Monitoring Report- Year 2
FINAL VERSION
Pen Dell Mitigation Project
Calendar Year of Data Collection: 2019

NCDEQ DMS Project Identification # 97079
NCDEQ DMS Contract # 6824
Neuse River Basin (Cataloging Unit 03020201)
USACE Action ID Number: SAW-2016-00885
NCDEQ DWR Project # 2016-0403
Johnston County, NC
Contracted Under RFP # 16-006477
Data Collection Period: June-October 2019, Submission Date: December 2019

RE: WLS Responses to NCDEQ DMS Review Comments for Task 8 Draft Monitoring Report Year 2 for the Pen Dell Mitigation Project, NCDEQ DMS Full-Delivery Project ID #97079, Contract #006824, Neuse River Basin, Cataloging Unit 03020201, Johnston County, NC

Figure 1	Current Condition Plan View (CCPV)
Table 5	Visual Stream Morphology Stability Assessment
Table 5a	Vegetation Condition Assessment
Photos	Stream Station Photographs
Photos	Vegetation Plot Photographs

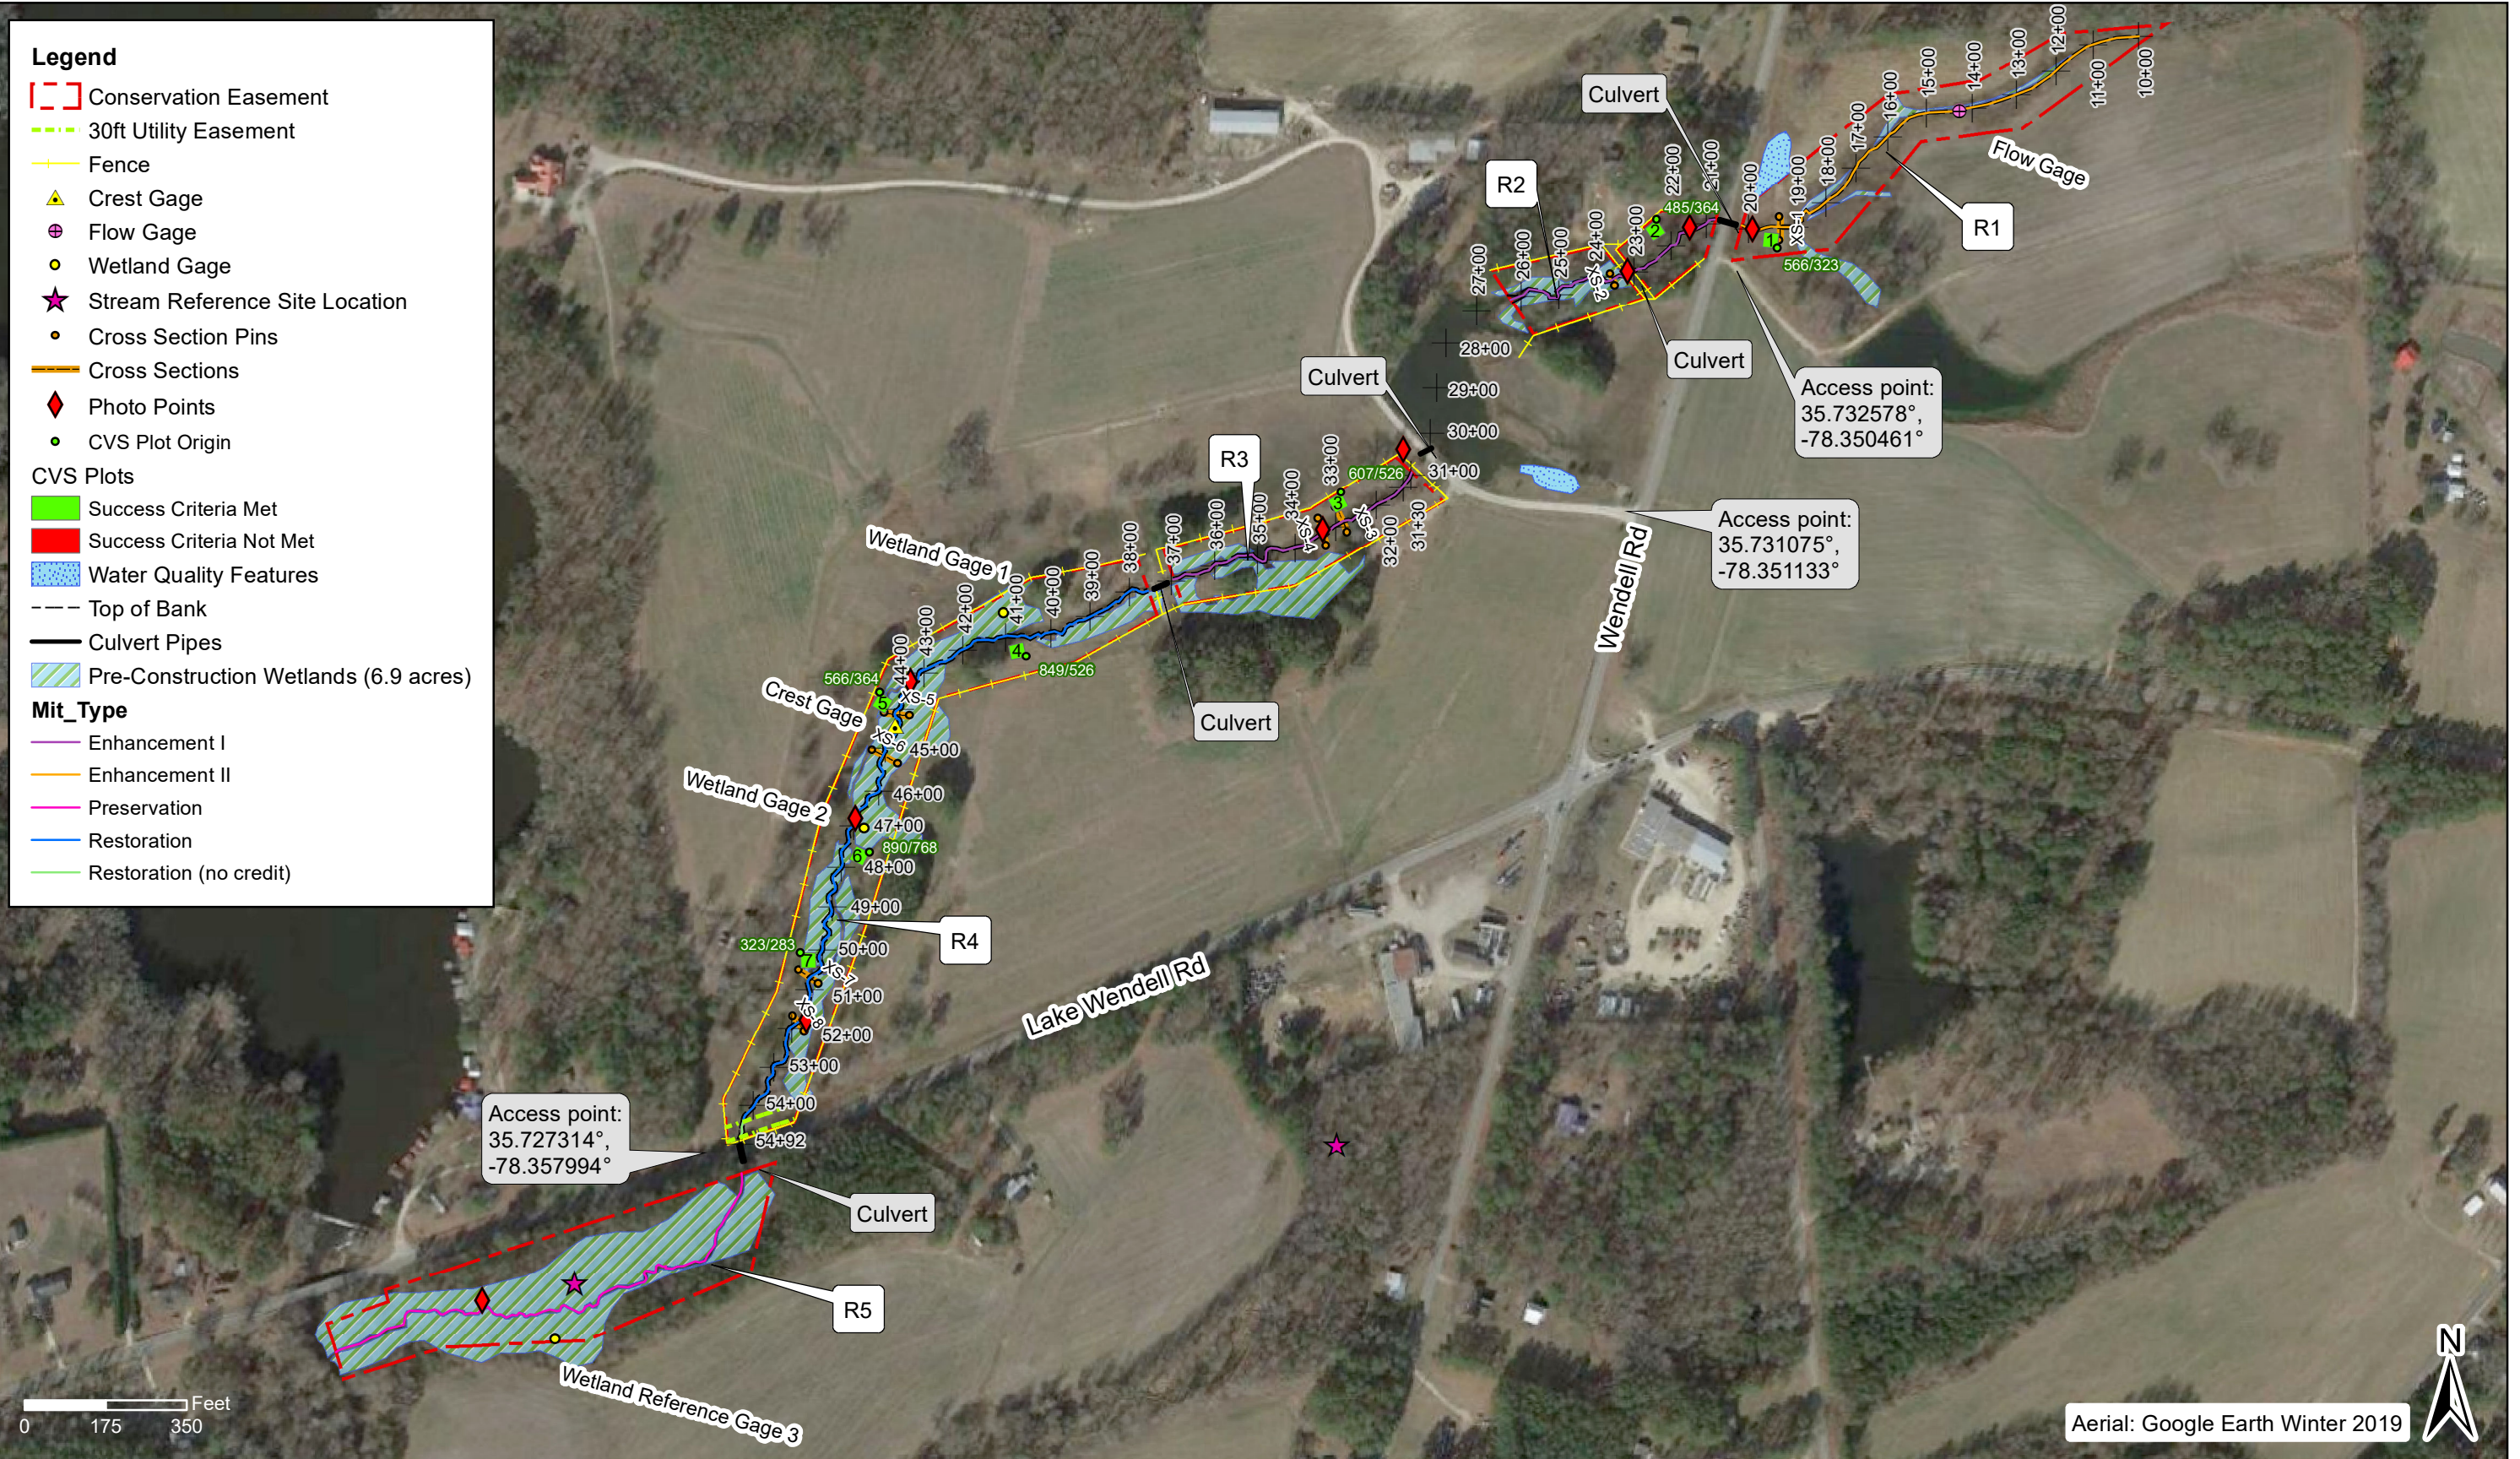
7. **Do not see the utility that impacts R4 in CCPV. This reach should be segmented in CCPV and spatial (GIS file).** WLS Response: A 30ft utility offset was added to the CCPV and the stream was updated accordingly.
